ZONING BOARD OF APPEALS

1. Minutes of Previous Meeting(s)
2. Consider a Request by Senegy Builders, LLC for a Variance to Reduce the Required First Floor Height from 15 feet to 12 feet 4 inches Located at 130 North 4th Street.

Grand Junction Planning Commission

Consider a Request by Senegy Builders, LLC for a Variance to Reduce the Required First Floor Height from 15 feet to 12 feet 4 inches Located at 130 North 4th Street.

DATE: 01/14/2019 SHEET NO:

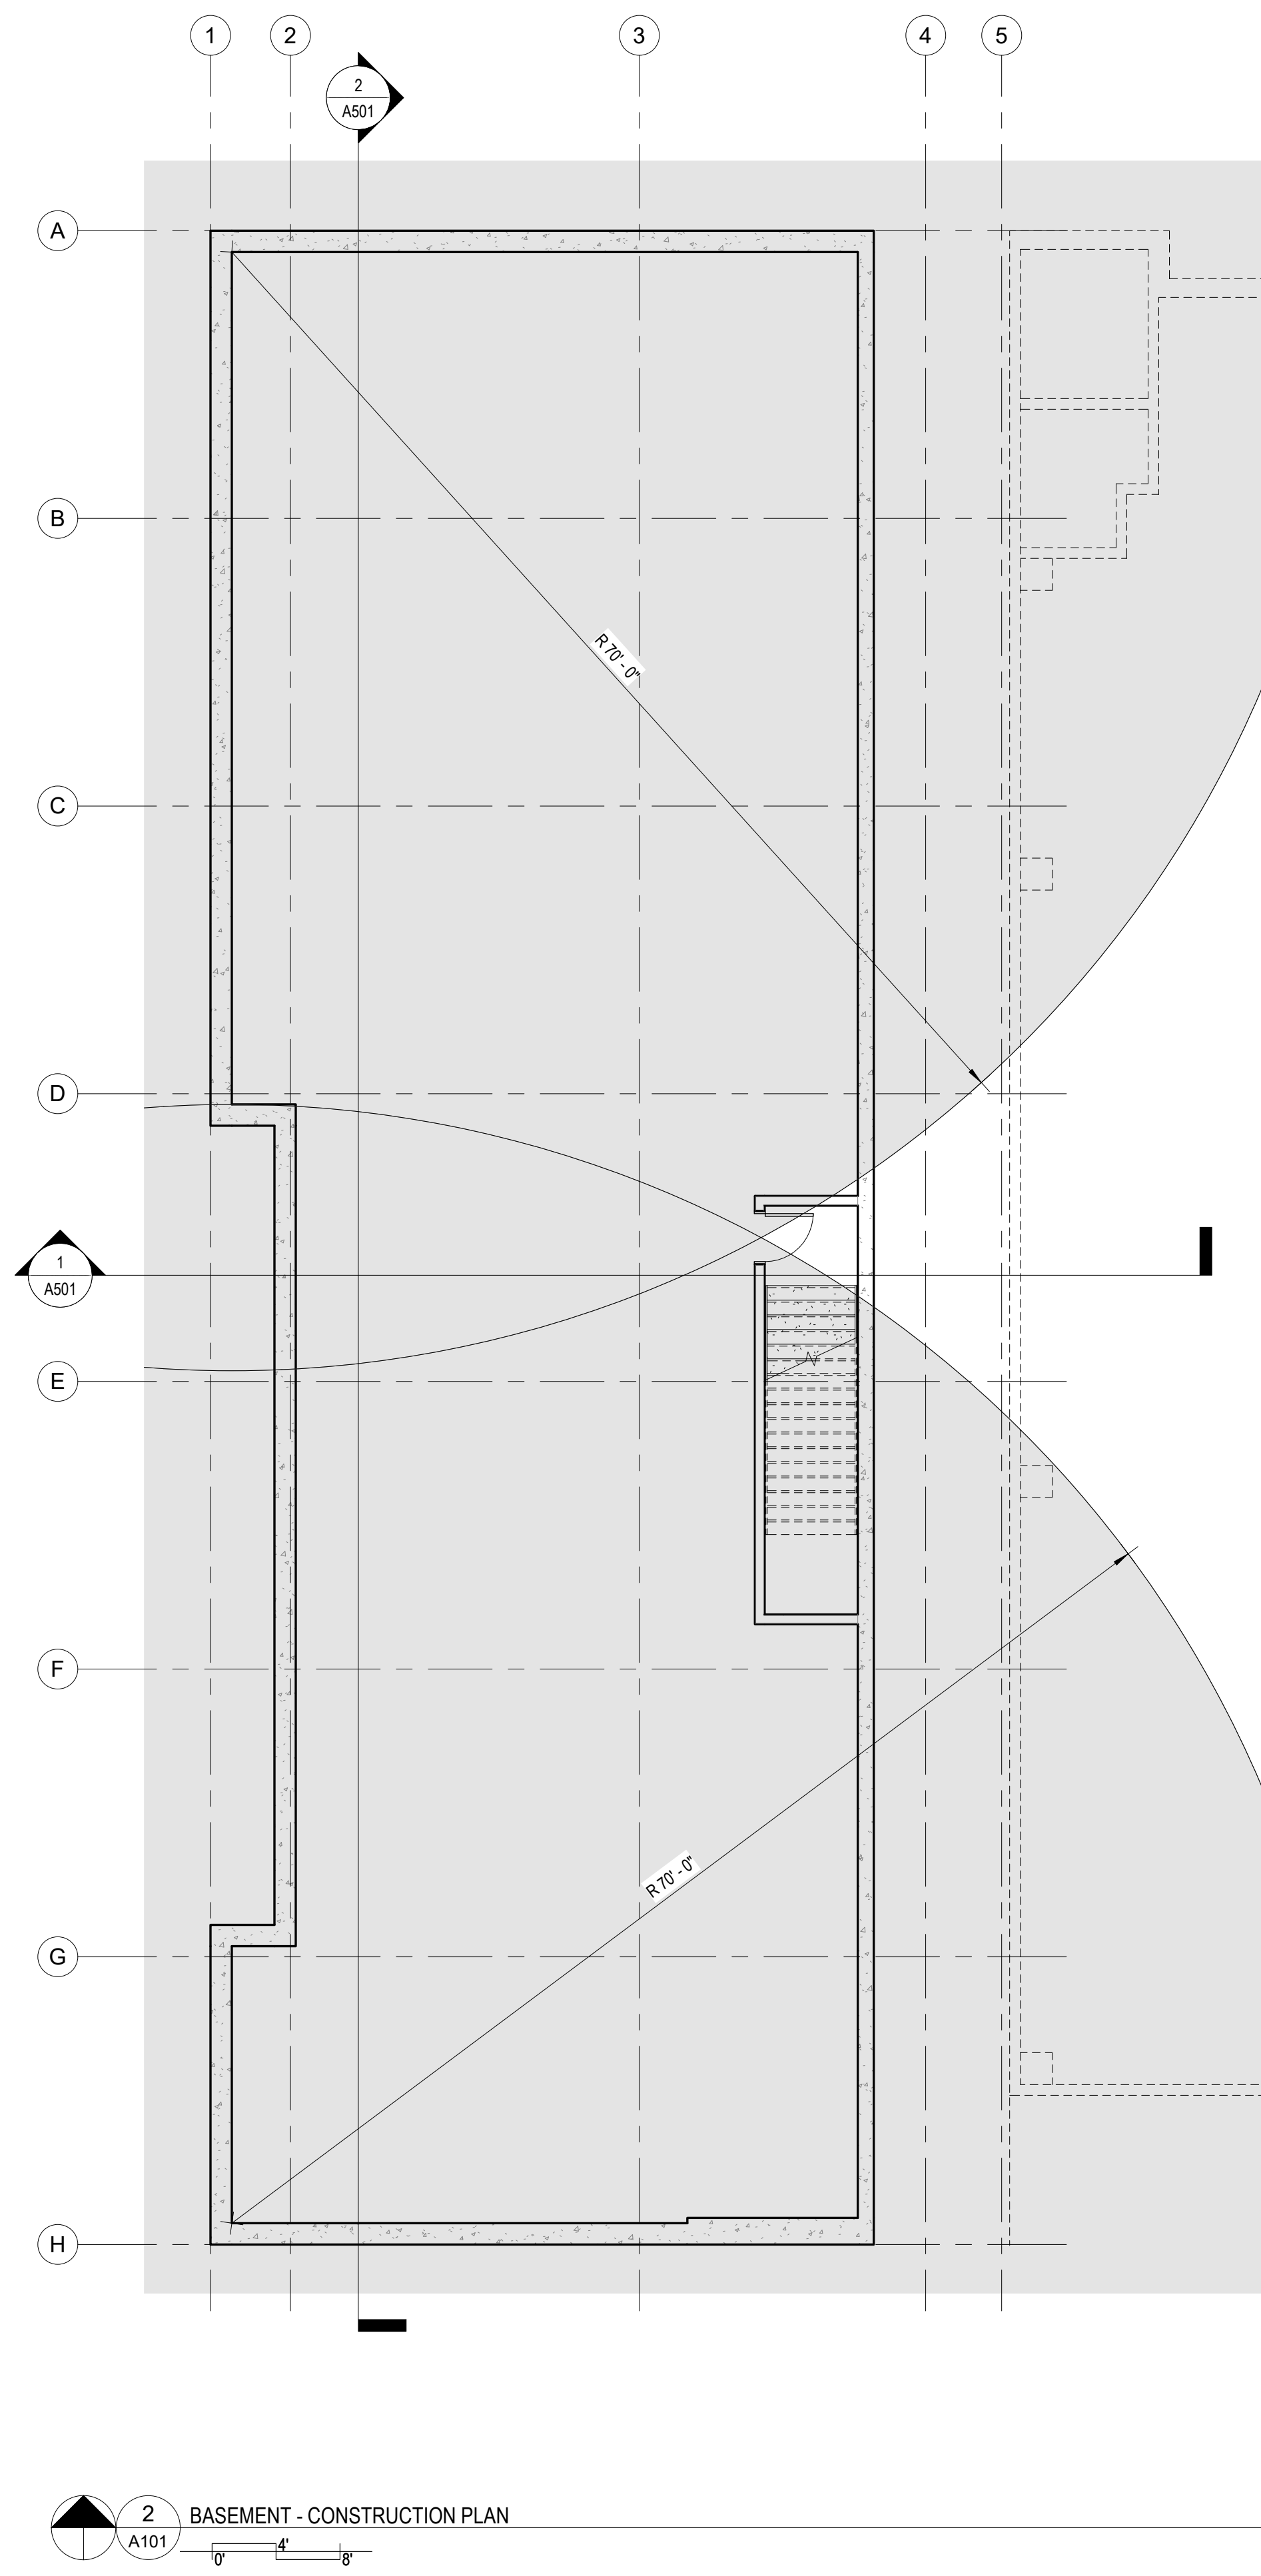
Furthermore, the difference visually may not be perceptible to the public or to users of the building when completed, especially in consideration of the awning that are proposed that will be installed at 14 feet 4 inches. In addition, the bulk standard of the minimum floor height was established in part in the event a new building was constructed downtown directly adjacent to a historic building. so the horizontal alignment was consistent along a street face. The first floor height in many of the historic buildings downtown have a relatively high first floor height so the 15-foot requirement for a new building would result in a horizontal alignment of building façade elements consistent with adjacent buildings. In this case, the proposed building is not directly adjacent to a historic structure so the need to be consistent with proportions on historic buildings is not relevant.

The architect has brought the glass line up to the ceiling height and then pushed up each of the steel canopy's an additional 2 feet in order to give the appearance of compliance while achieving the desired architectural standard. See architectural drawing sheet A201. It was the intent of the City and the DDA to build building on each of the RAPP Endcaps and connect the two structures to the parking garage and; to share the use of the two elevators. A 15 foot first floor height makes this unworkable.

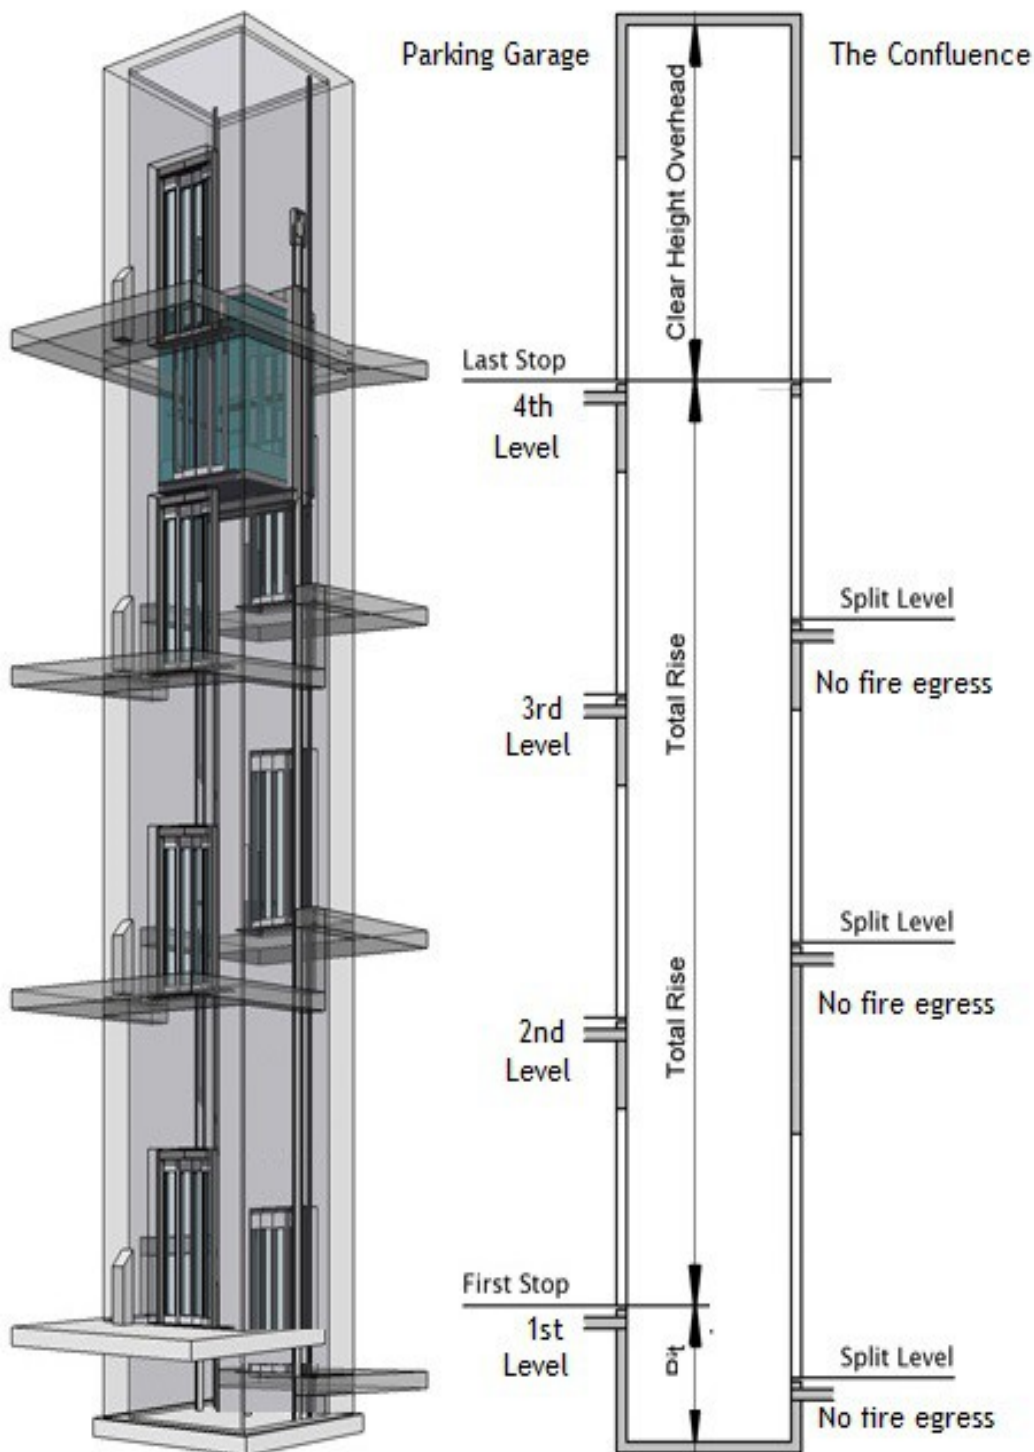
The request is to vary the first floor to a buildable height of 12 feet 4 inches in order to match the RAPP on each level. This will accommodate parking for residents of The Confluence while minimizing wear and tear on the elevator. Increased Fire, life, & safety concerns would also be minimized by creating 4 additional egress points, allowing another entrance and exit at each of the 4 floors.

If the first floor is required to be 15 feet, the 4 additional egress points, one more on each level, would be lost due to the nearly 3 feet offset between the floor of The Confluence and the RAPP. The loss of these 4 safety egress points makes the project much less desirable, much less safe.
